Applicant:	Walser Real Estate, LLC (Owner) Walser Toyota (User)
Location:	4401 American Boulevard West
Request:	<ol style="list-style-type: none"><li>1) Rezone a portion of 4401 American Boulevard West from CS-0.5(PD) to C-1(PD) for the expansion of a motor vehicle sales facility (Class I and II)</li><li>2) Major Revision to Preliminary Development Plans and Final Development Plans to construct a new three-story parking ramp with roof parking</li></ol>
Existing Land Use and Zoning:	Class I and II motor vehicle sales facility; zoned Commercial Service (Planned Development) and Single-Family Residential, CS-0.5(PD) and R-1
Surrounding Land Use and Zoning:	North – Interstate 494; public right-of-way South – Single-family residential dwellings; zoned R-1 East – Restaurant; zoned CS-0.5(PD) West – Office and multiple-family residential apartments; zoned CS-0.5 and R-4(PD)
Comprehensive Plan Designation:	Regional Commercial (RC)

In Case PL2020-55, I move to adopt an ordinance rezoning a portion of 4401 American Boulevard West from CS-0.5(PD) to C-1(PD).

In Case PL2020-55, having been able to make the required findings, I move to approve a Major Revision to Preliminary Development Plans

**Figure 1: Rezoning from CS-0.5(PD) to C-1(PD)**

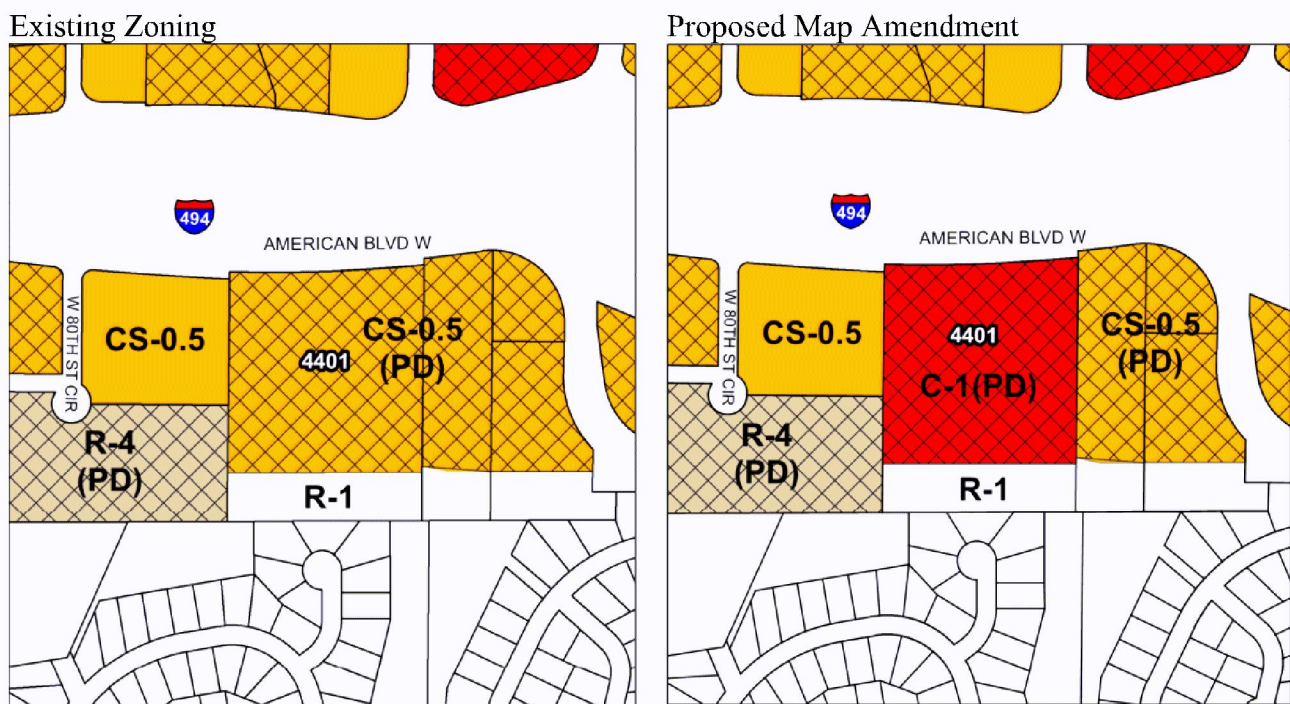
The subject property existing base zoning is split between CS-0.5 and R-1. The northern 80 percent of the site is zoned CS-0.5(PD), while the southern 20 percent (150 feet from the southern property line) is zoned R-1. The applicant requests rezoning the northern 80 percent of the site from CS-0.5(PD) to C-1(PD), as shown in Figure 1. In the CS-0.5 zoning district, a Class I motor vehicle sales facility is a conditional use, whereas it is a permitted use in the C-1 zoning district. The C-1 zoning district is intended to provide for a variety of non-retail uses that benefit from exposure and/or proximity to freeway corridors and interchanges, including Class I and II motor vehicle sales. There are currently only three other sites in the city zoned C-1, all of which are Class I and II motor vehicle sales facilities. A motor vehicle sales facility is a conditional use in the CS-0.5 zoning district, previously requiring the approval of Conditional Use Permits as the current facility was developed and expanded through the years. Rezoning the site to the C-1 zoning district would remove the requirement for a Conditional Use Permit, as motor vehicle sales uses are permitted in the C-1 district.
